Modify the flood defence sea wall on James Larkin Road, D3 between Mount Prospect Avenue D3, and Watermill Road, D5.

#### 1. Proposed Development

The 'Sutton to Sandycove Cycleway & Footway Interim Works: Bull Wall to Causeway Road' scheme was approved the City Council in 2012 (Report No. 3601/12). It has now been constructed.

Figure 1: Location Map: Shaded Area indicates extent of the Proposed Wall Lowering

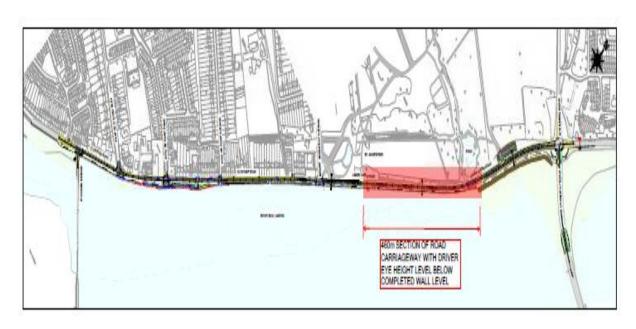
Following significant pressure from members of the public, a series of meetings with representatives of the community and the engagement of an independent expert it is now proposed to reduce the height of the flood defence sea wall from a height 4.25m OD\* to a height ranging from 4.06m OD to 3.95m OD to give a minimum flood defence height of 3.95m OD and pedestrian parapet of a minimum of 500mm high over a distance of circa 460m from the northern end of the wall. It is also proposed to provide cladding of the roadside face of the wall with blue limestone and to provide a reconstituted stone coping and to undertake associated ancillary works.

Details of the proposed modifications to the height of the sea wall are given in the table on the next page, together with a location map of the area that will be subject to wall lowering.

Proposed Blue Limestone Wall

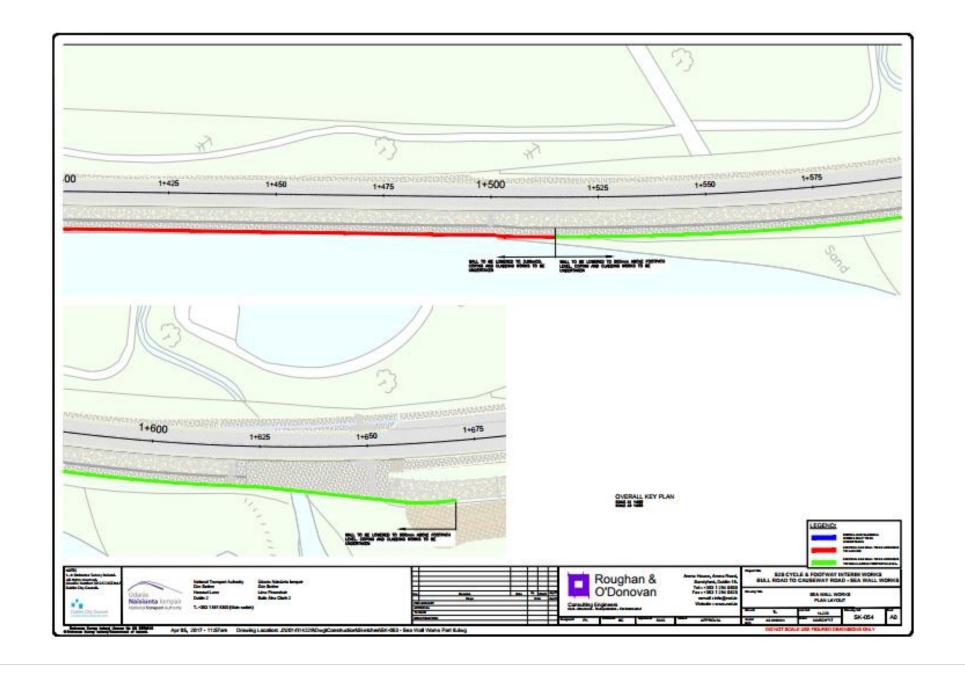
The original scheme made provision for a concrete rendered finish to the roadside face of the wall. Following consultations with the EMLC it is now proposed to provide a different finish to the section of sea wall from the Mount Prospect junction north. This section is adjacent to St. Anne's Park, which has a low random rubble boundary wall on the west side of the road. It is now proposed to provide a blue limestone cladding. A sample section of this treatment has been provided on site.

(i) A reconstituted stone coping and limestone cladding of roadside face of the sea wall shall be constructed along the frontage of St Anne's Park. Any deviations from this shall be agreed with the Planning Department of Dublin City Council.
